SEWAGE DISPOSAL SYSTEM
HOWARD COUNTY HEALTH DEPARTMENT
BUREAU OF ENVIRONMENTAL HEALTH
410-313-2640

SUBDIVISION Cattail Creek Country Club LOT NUMBER 13 ADDRESS 3645 Broadleaf Court

SITE PLAN
BROADLEAF COURT

DRIPLINE DISPOSAL DESIGN
 FOR
LOT 13 "CATTAIL CREEK COUNTRY CLUB"

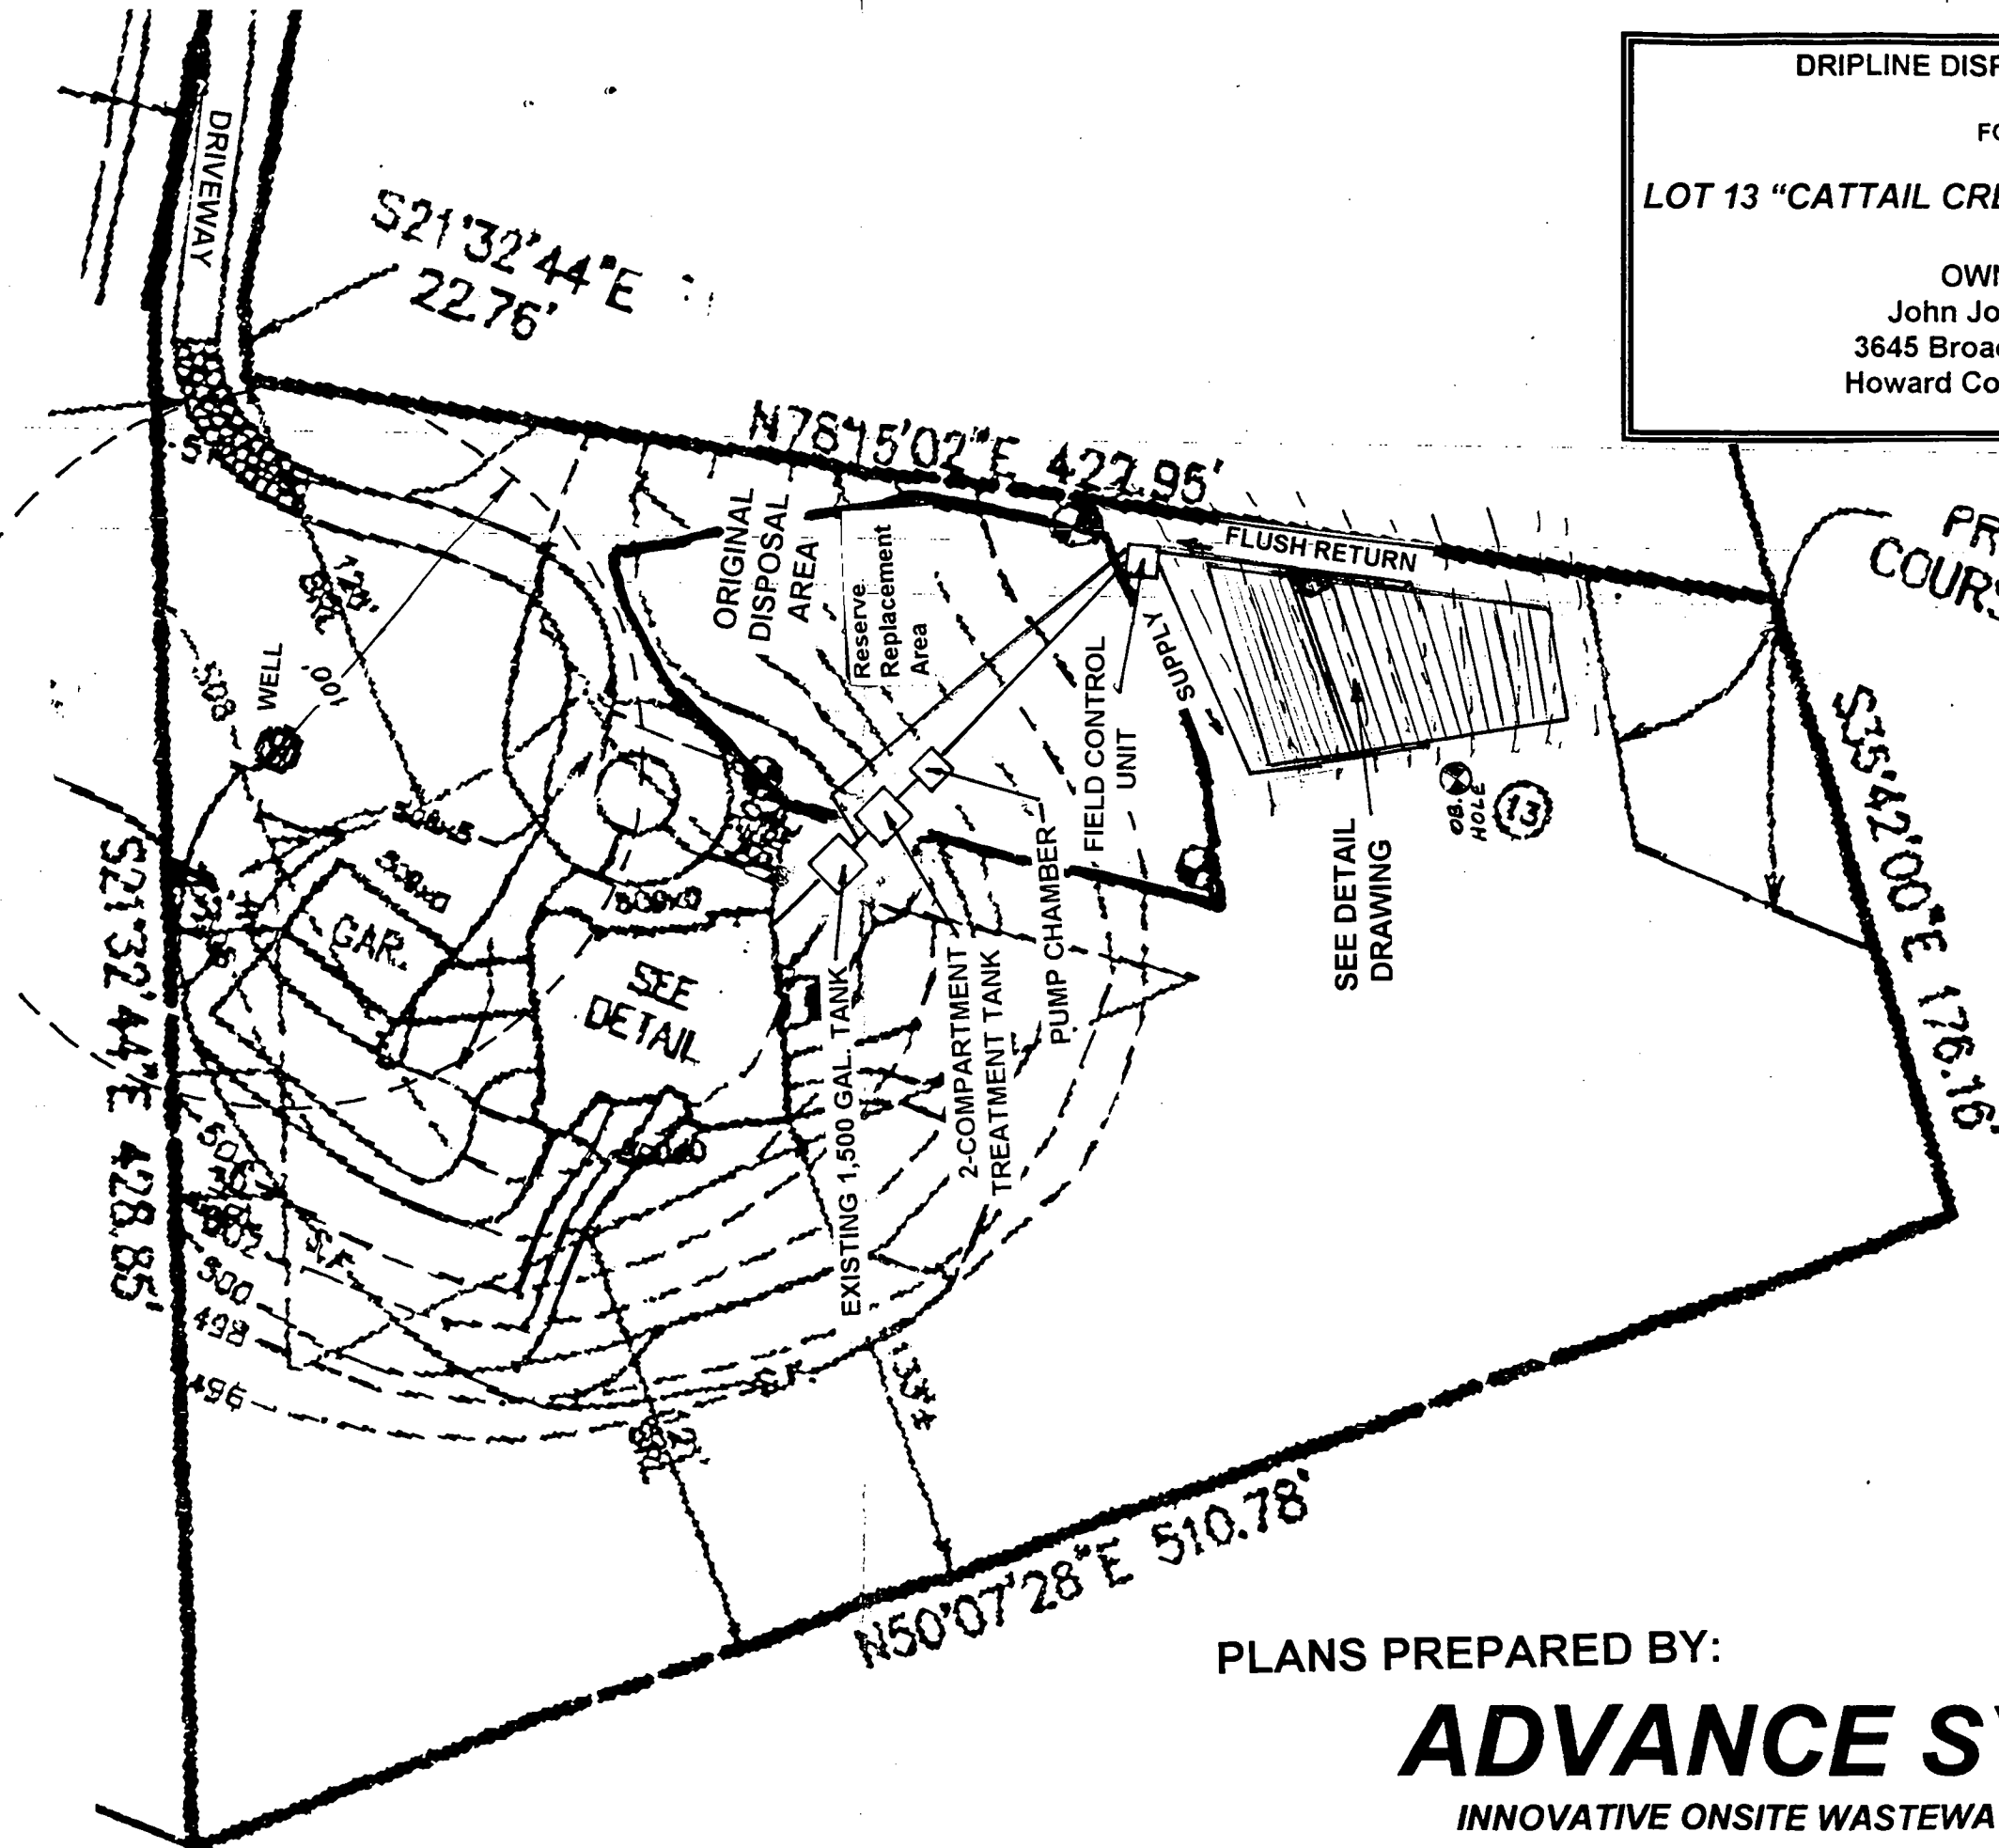
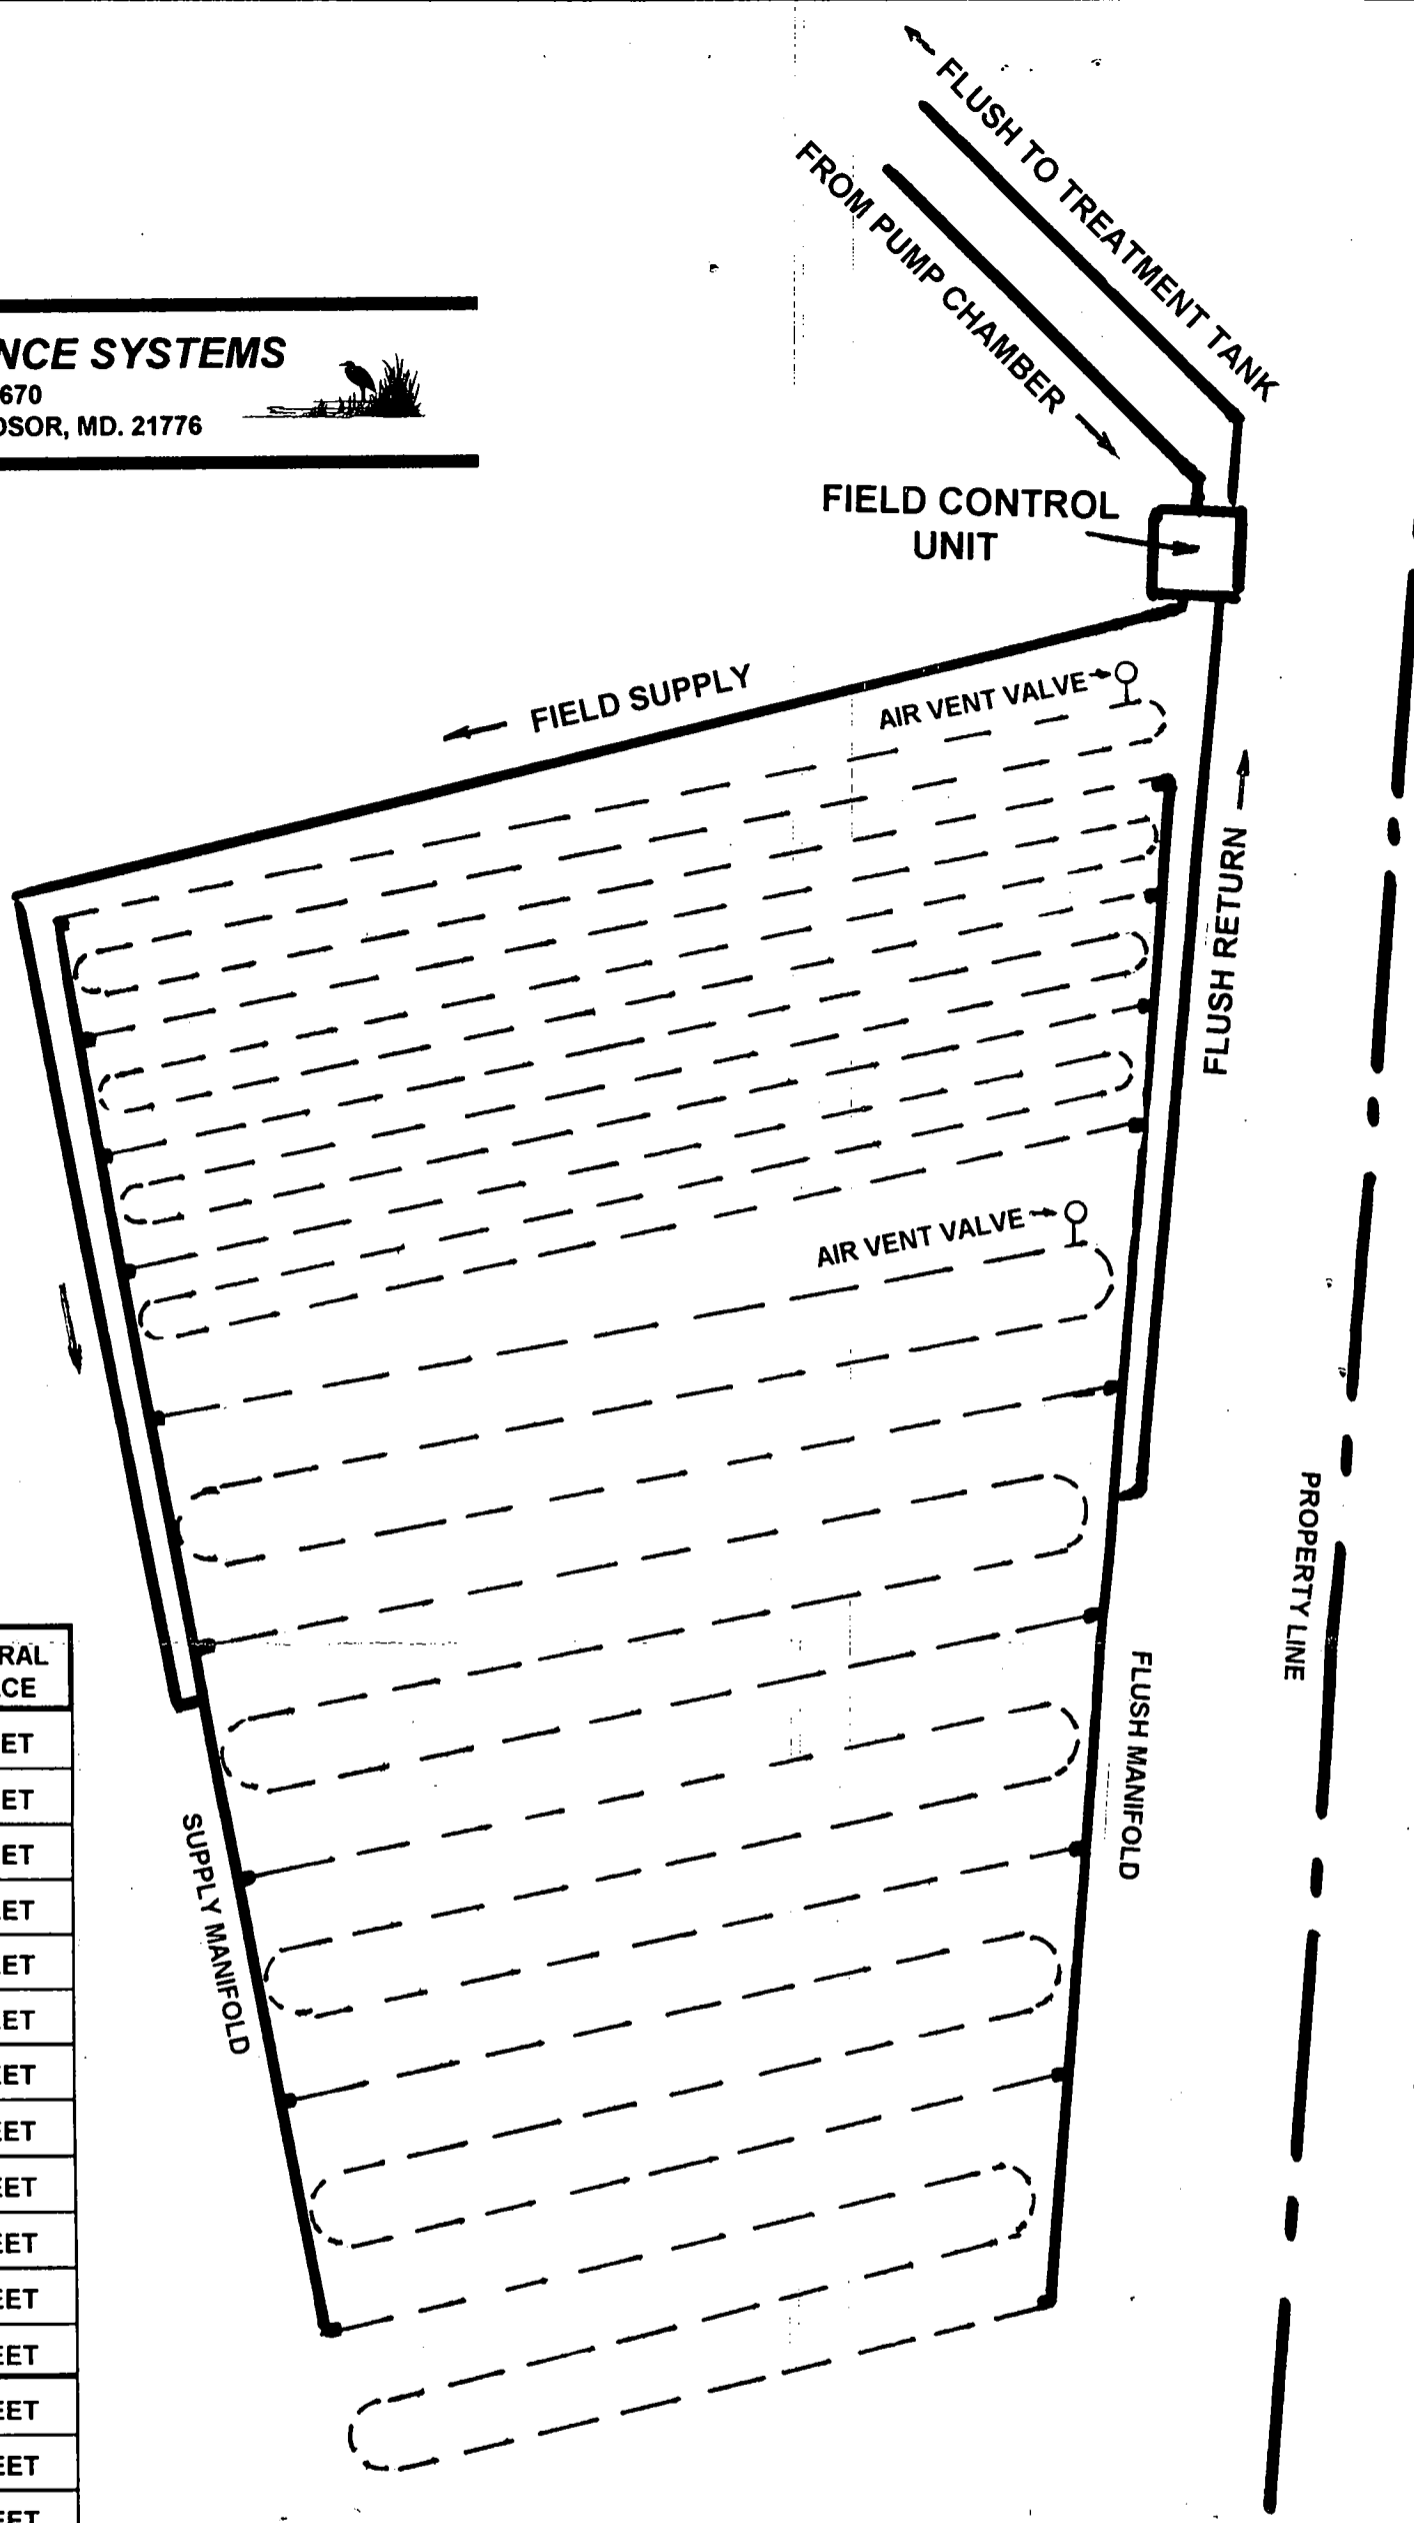
PRE-CONSTRUCTION INSPECTION: Flt pipe length is longer than on plans, times adjusted to 2' drain run. Permit
As built plans to be submitted by Advance System (see Mike Robbins 410-875-9100) 5/26/01

*Expect as built set of plans
(extra length of digger line was added
which changed some parameters)
part of lot line / R. Pulley 6/5/01*
